**RE: 15605 El Gato Lane**

I reviewed the drawings, and evaluated the site context. My comments and recommendations are as follows:

*Proposed Rear Elevation*

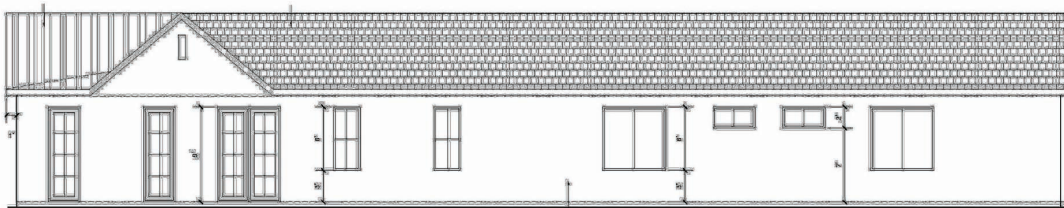
This is perhaps the primary issue or set of issues regarding this proposed design. As currently designed, the structure is a uniform rectangular box married to a front portion that is totally different in form and detail.

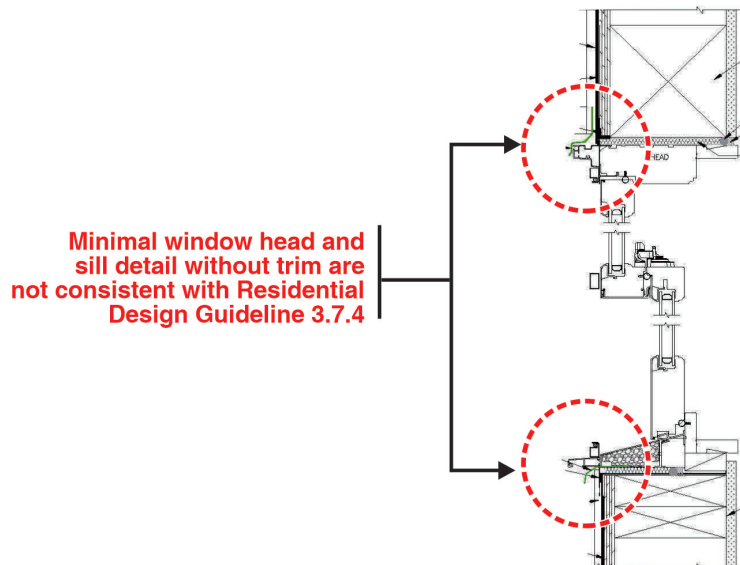
While there is some variation in the front facades of nearby homes, most follow the simplicity of the Eichler design style.

This window are set close to the exterior face of the wall, have minimal and non-traditional head and sill details, and lack window trim all of which are not consistent with Residential Design Guideline 3.7.4.

*Recommended Rear Elevation*

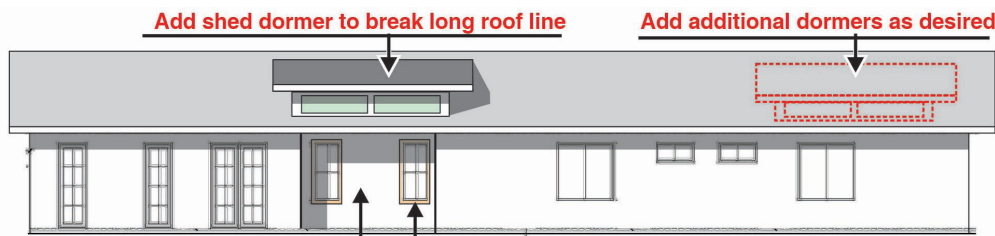
Break long facade with recess

Add wood trim to all windows and doors consistent with Residential Design Guideline 3.7.4

**Another Approach**

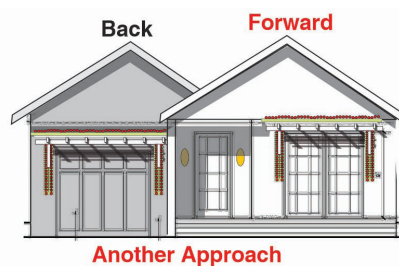
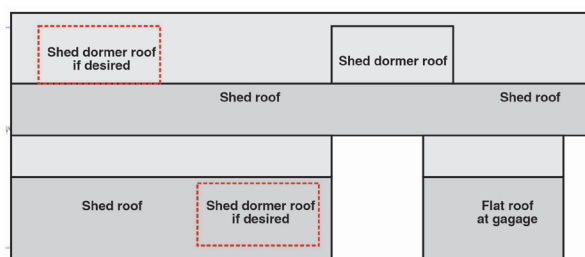
I feel that I could also recommend one other approach that I studied. It is more similar to the applicant's proposed design, but simplified in a traditional style found throughout Los Gatos. The alternate front elevation and roof plan are shown below. This alternative approach would require some minor floor plan changes.

- Moving the face of the garage back from the front facade by a minimum distance of 3 feet.
- Adjust garage recess by either reducing the depth of the garage, reducing the size of the exterior patio, reducing the dimensions of the bedrooms on this side of the house, or a combination of these adjustments to achieve the garage setback.

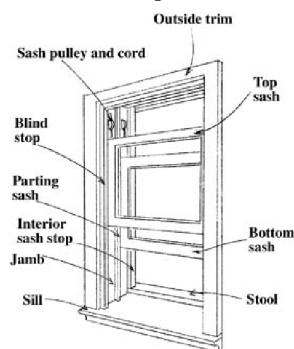
1. Change the roof forms to shed and flat or gable roofs, and eliminate metal roofing - see nearby neighborhood examples below.
